To: Michel Kearney, P.Geo. – City of Ottawa
From: Rob Kell, M.A.Sc., P.Eng., P.Geo., Dillon Consulting Limited
cc: Brent Loney, M.Sc., P.Geo., Dillon Consulting Limited
Date: May 15, 2020
Subject: Review of Caivan - ABIC - Groundwater Field Investigation Memo
Our File: 20-2859

Figure 1 - Site Plan (Plan is from the Paterson Memo with water levels at the monitoring wells / piezometers recorded in November 2019)

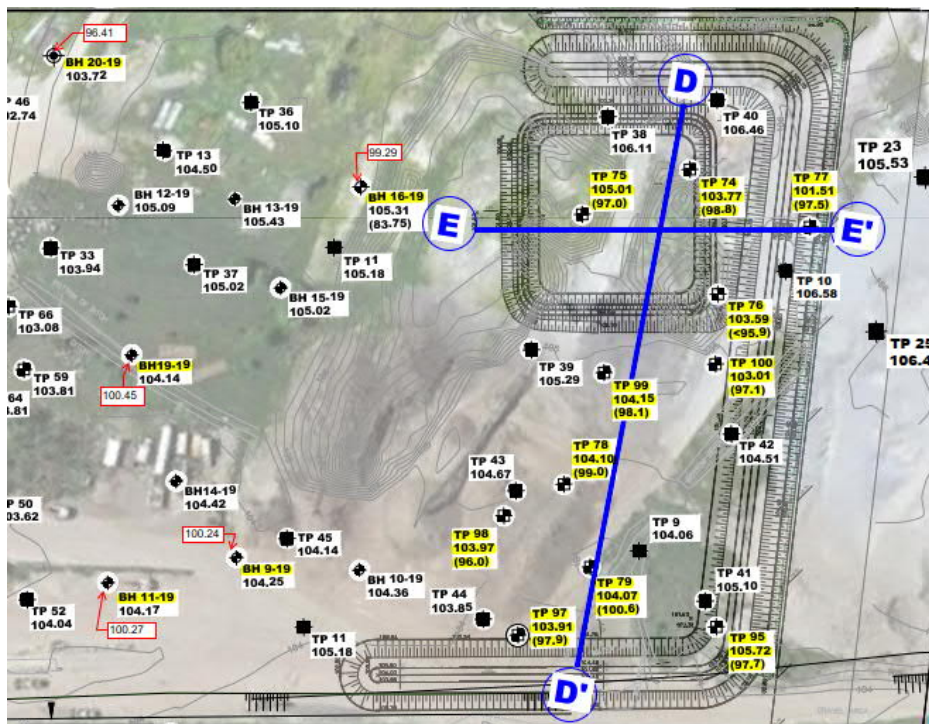
Eleven test holes were excavated to approximately 96 to 99 masl on May 6-8, 2020. Four test pits (TP74, TP75, TP76 and TP77) were excavated in the area of the proposed infiltration gallery and one test pit (TP78) excavated in the area of the proposed septic tank to a depth of 5.1 m (99.0 masl). The remaining test pits were located south of the proposed infiltration gallery. Water levels were recorded in the test pits which were left open for about 48 hours. The use of test pits to assess groundwater conditions, while not as technically appropriate as monitoring wells, can be useful to provide a qualitative assessment of near-surface groundwater conditions. Monitoring wells / piezometers were installed in November 2019 west of the proposed and groundwater elevations measured in November 2019 in those installations were generally higher than those measured in the test pits (these levels are tabulated below and are shown on Figure 1 derived from the Paterson Site Plan figure).

With the exception of one test pit (TP74), inferred groundwater levels in the test pits were at or below the bottom elevation of the proposed infiltration gallery 97.5 masl. The water level at TP74 was at 98.8 masl, 1.3 m above the bottom excavation of the proposed infiltration gallery. The higher water level at this test pit was attributed by Paterson to lower hydraulic conductivity fill material noted within the test hole. Paterson states that the lower hydraulic conductivity fill material in the area " ... contains limited groundwater" and concludes that construction dewatering is not expected to be required when constructing the infiltration gallery. We assume that Paterson meant that these materials would conduct less groundwater, such that construction dewatering requirements would be minimal. Dillon has reviewed the groundwater conditions in this general area which indicate that interpolated groundwater levels are generally at an elevation of 97.5 masl (corresponding to the bottom elevation of the proposed Infiltration Gallery). As such, we have no information that would contradict the Paterson conclusion that construction dewatering is not expected to be required.

Test pit TP78 was excavated to a depth corresponding to the proposed bottom of the tank (99.0 masl). The test pit was dry and, as such, Patterson concludes that construction dewatering will not be required during the installation of the septic tanks. It is noted that the water level at TP79 (located approximately 25 m south of TP78) was at an elevation of 100.6 masl. Water levels at other test pits excavated nearby support a groundwater elevation less than 99.0 masl. As stated above, Dillon's review of the groundwater levels in this general area indicates levels less than 99.0 masl, and we have no information that would contradict the Patterson conclusion that construction dewatering is not expected to be required in the area of the septic tank.
